Plan Change Number and Name: **Plan Change 13 – Uplifting Deferred Zones**

STATEMENT OF EVIDENCE OF BRONWYN RHYND

To: Papamoa TA Limited Partnership
From: Tony Wang – Engineer
Reviewed: Bronwyn Rhynd – Director
Re: **Stormwater strategy review - T6 -164 St Leger Road, Te Awamutu**

STATEMENT OF EVIDENCE OF TRACEY ANNE MORSE

**PROPOSED WEST T6 CELL
 OVERLAY AREA
 (Brill Road/ St leger road)**

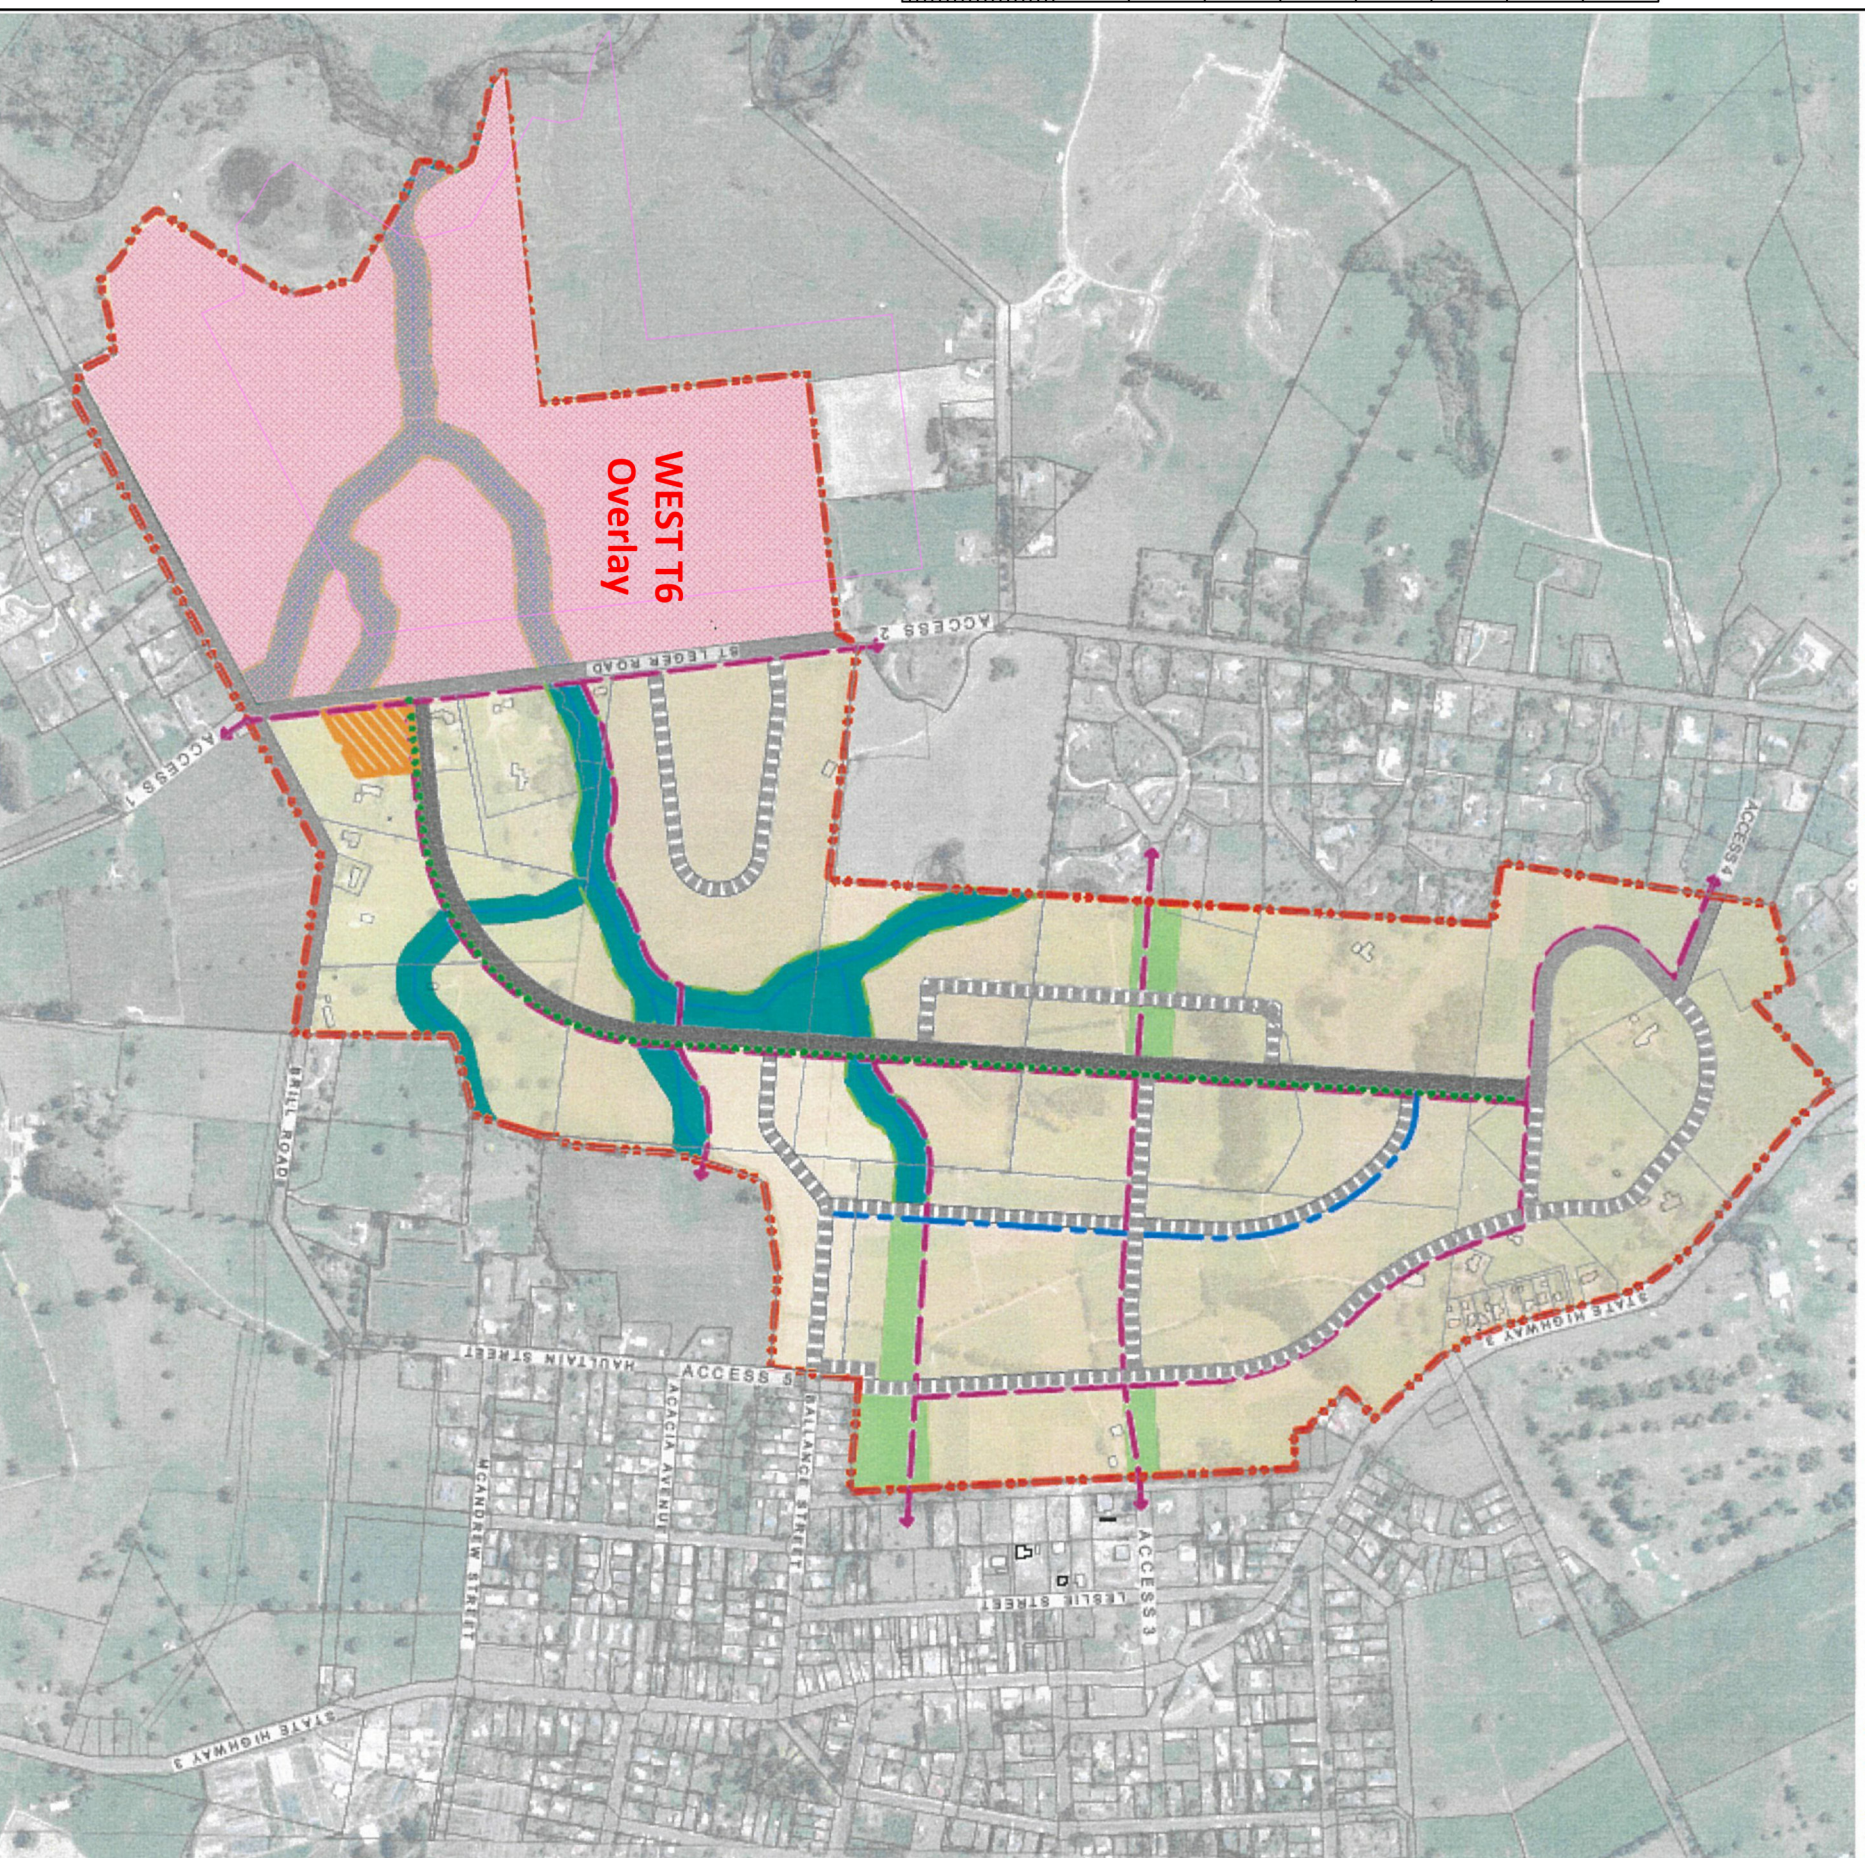
As such, the Submitter requests that the structure plan for the T6 growth cell as it relates to 164 St Leger Road be amended to:

- Remove the two 18m local roads;
- Remove the stormwater reserve area north of the stream that runs east/west through the property that is located beyond the 23m buffer of the stream; and
- Upon removal of the local roads and stormwater reserve area, an overlay should be added to the plan that identifies that:
 - Any application for resource consent to develop the property is subject to stormwater management calculations and design in relation to demand for additional stormwater reserve/s, transportation assessment for road layout, and urban design for overall development layout.

The plan **appended** to this submission shows the changes outlined above that the Submitter seeks to have made to the structure plan for the T6 growth cell as it relates to this property.

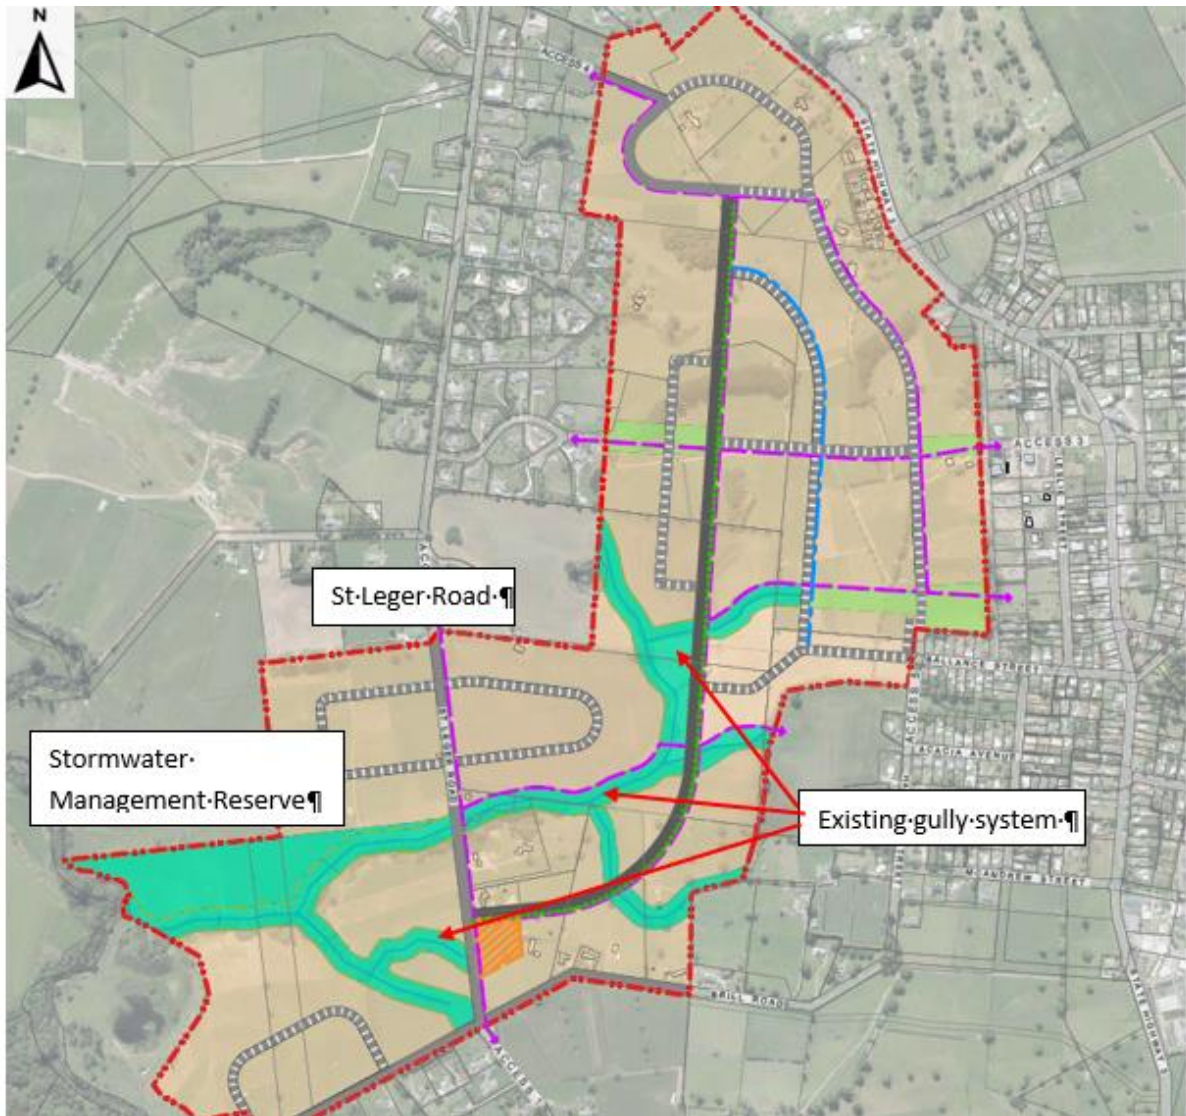
3.4 In applying the above requirements, or objectives, to the area west of St Leger Road and north of the Puniu River tributary has highlighted that the structure plan stormwater reserve located in the far western sector of growth cell T6, is either redundant or unable to be utilized to its full extent.

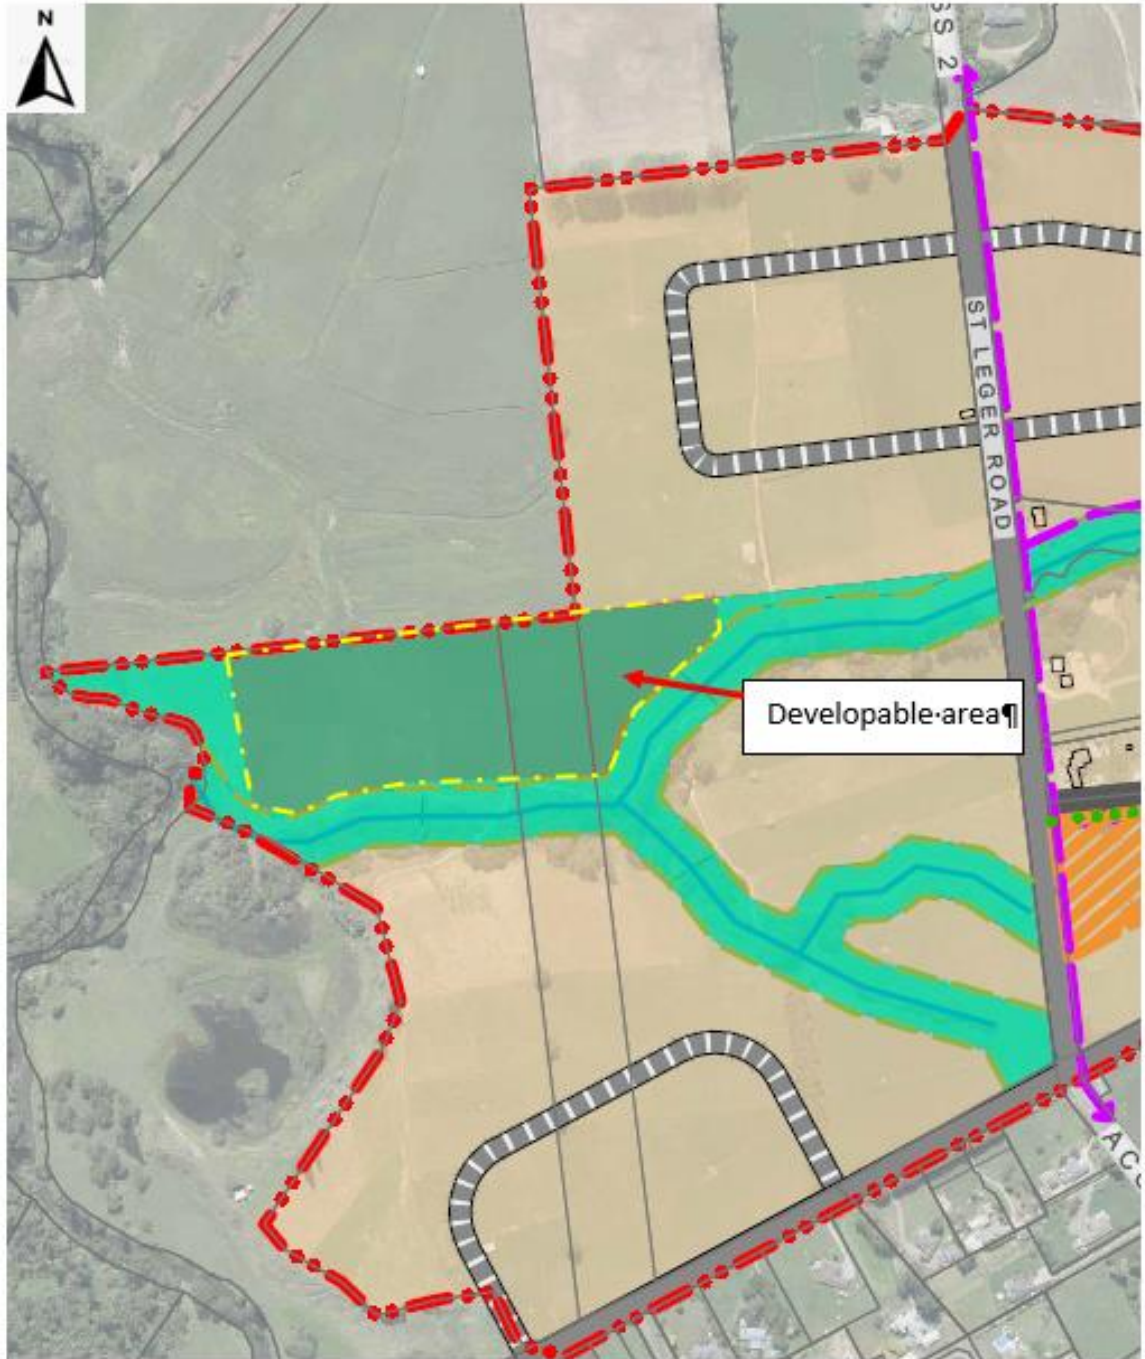
- 5.1 A review of the structure plan's stormwater management proposed for the sub catchment west of St Leger Road and north of the tributary highlights the following:
- the stormwater reserve is located in an area which is elevated and unobtainable for the majority of the Growth Cell T6.
 - stormwater management could be achieved “at source and on lot” for this sub catchment

- 5.2 Based on these findings this area could have the same development potential as the areas south of the tributary and west of St Leger Road.
- 5.3 Therefore, the land currently assigned as a stormwater reserve, as presented below, can potentially be developed into future residential subdivision.

Figure 1: T6 structure plan

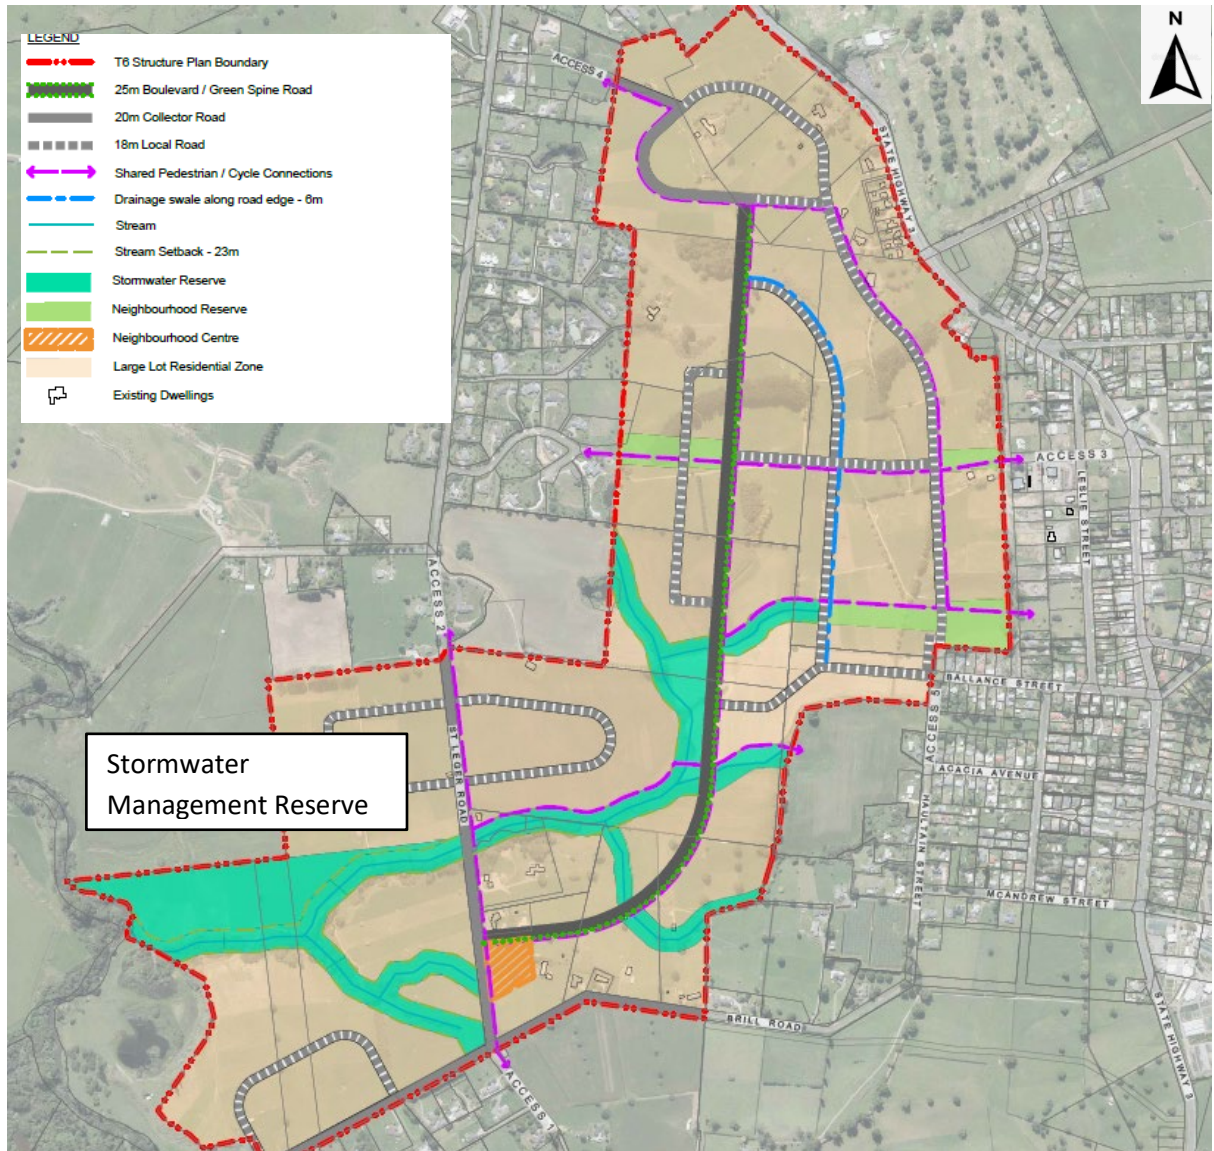
The T6 structure plan has been developed with stormwater reserves and conveyance systems to support the total growth cell. The proposed stormwater management areas which include reserves and stream setbacks is shown in Figure 1.

Figure 2: Channel and Gully Locations

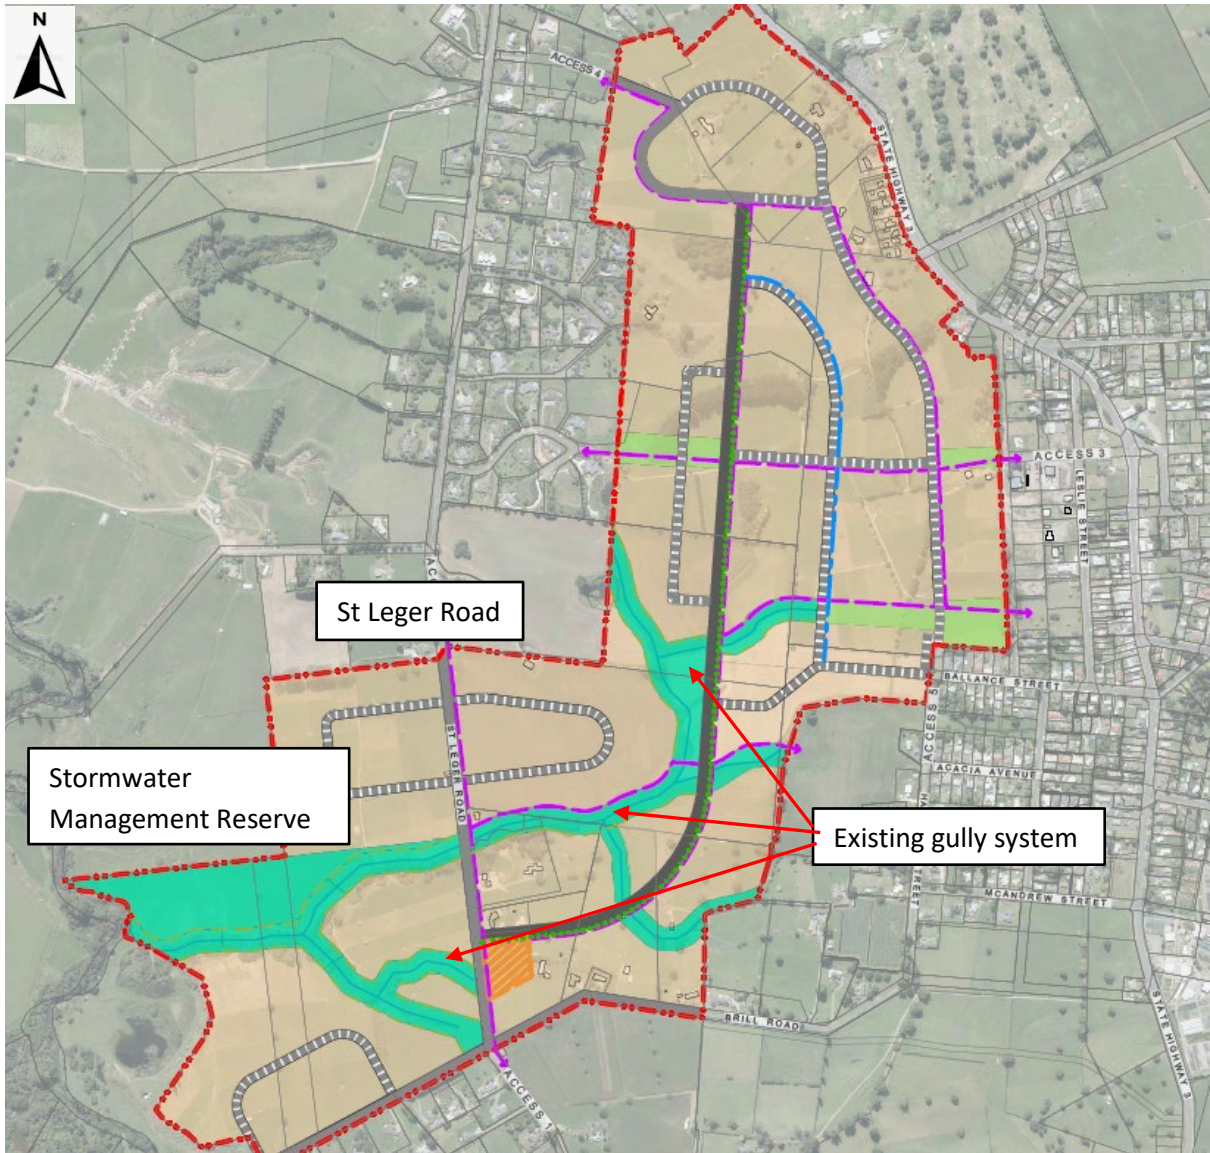
The existing gully and proposed channel system are shown in Figure 2. The existing gully and channel are shown as intercepting and conveying flow from within the T6 growth cell towards the Puniu Stream. There is no connection as to how the stream and gully system will utilise the stormwater reserve as the following aspects have not been considered:

- Stormwater management reserve is elevated above the channel and gully system
- The reserve can only receive runoff from the sub catchment west of St Leger Road and north of the tributary due to topographical constraints

In addition should there be a system that utilised a stormwater reserve (should the topography allow) then the primary system would bypass tributary and the resultant starvation of the tributary would occur.

The biggest concern with the location of the stormwater management reserve is that it is elevated above the adjacent channel and gully, see Figure 3. Therefore, it is considered difficult and ineffective to convey the flow across the St Leger Road and towards the stormwater management reserve.

Figure 4: Developable area

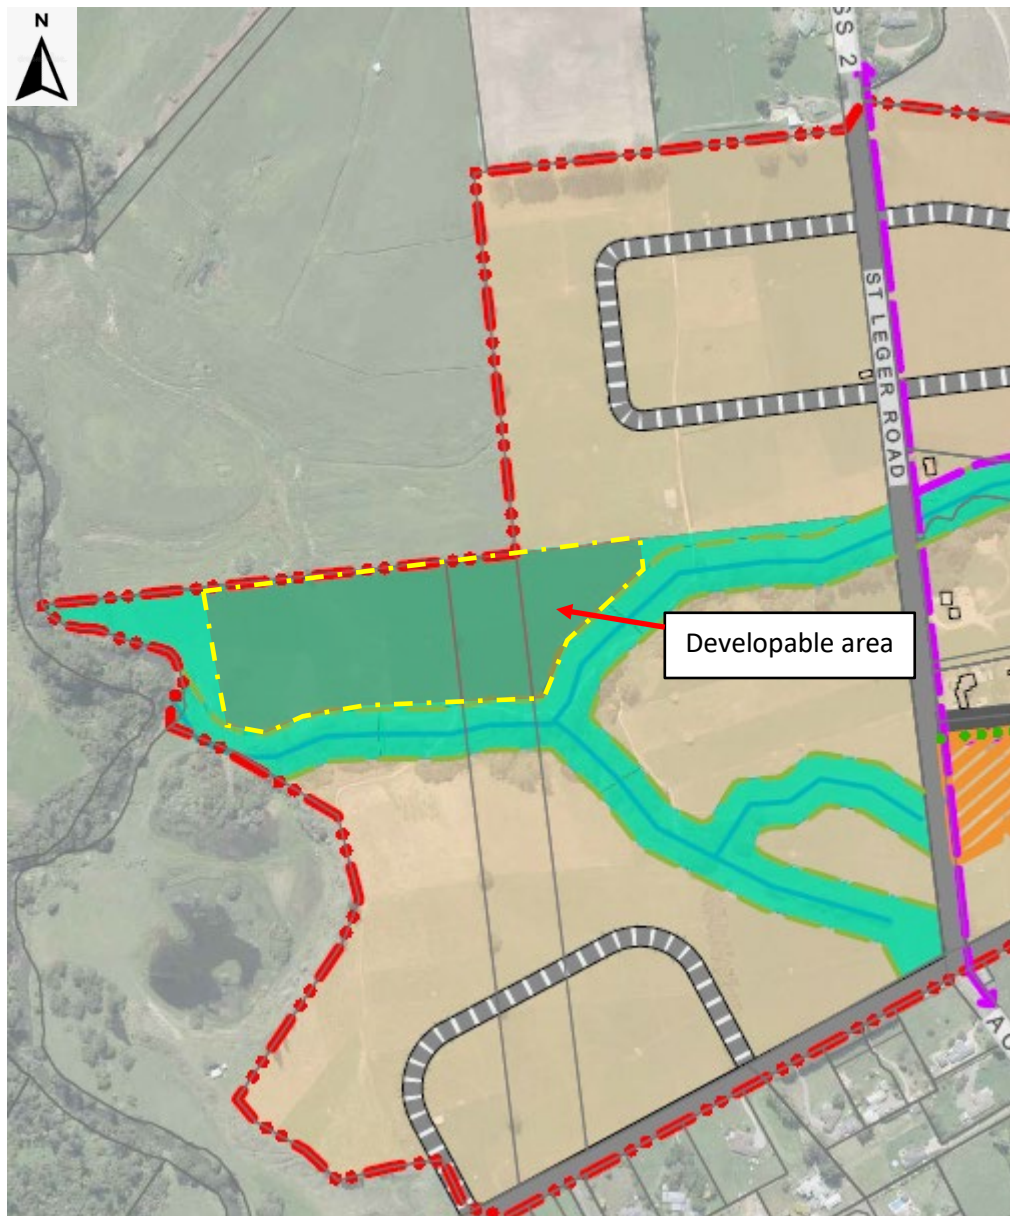
As stated in the reporting, as per Section 2, the water quality treatment volume could be achieved at source and on lot. Therefore it is considered that the land currently assigned as a stormwater reserve can potentially be developed into future residential subdivision.

As presented in the Structure plan the sub catchment west of St Leger Road and north of the tributary could have the same development potential as the areas south of the tributary and west of St Leger Road. Therefore, the stormwater reserve is considered oversized.

The land that could potentially be development is show in Figure 4.
